August 24, 2010

SeaWind Class – Rule Interpretation – Rule 10.2

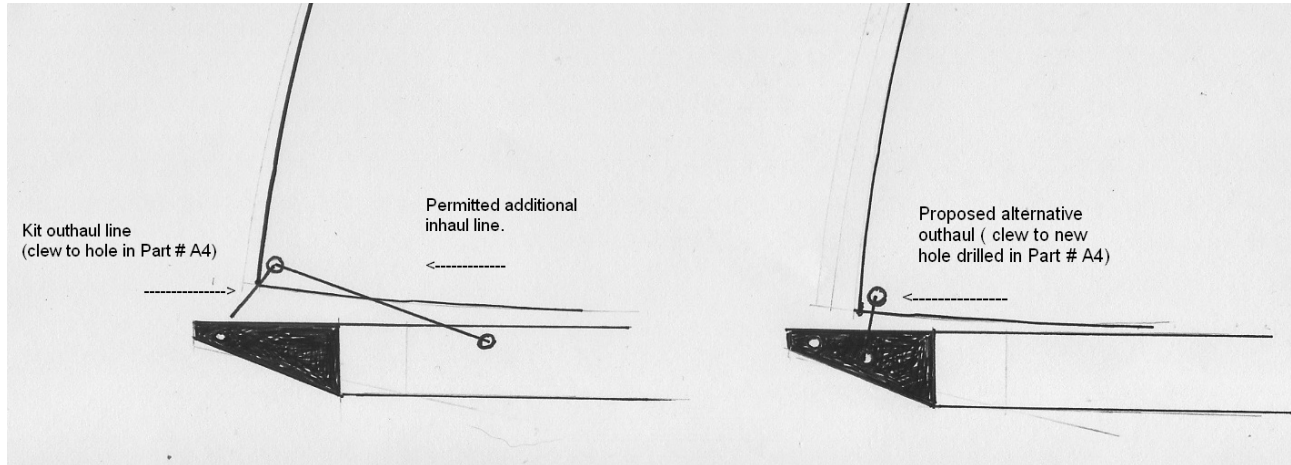
A skipper asked if an alternative outhaul arrangement would be permitted. The diagram below illustrates a conventional outhaul arrangement and his proposed alternative.

After discussion among the SeaWind Class Officers it has been agreed that the proposed alternative arrangement, although probably providing little if any advantage, is not permitted.

The proposed arrangement which requires a new hole in the plastic end piece to which the outhaul line from the clew is secured is judged to be outside the scope of modification permitted under Rule 10.2.
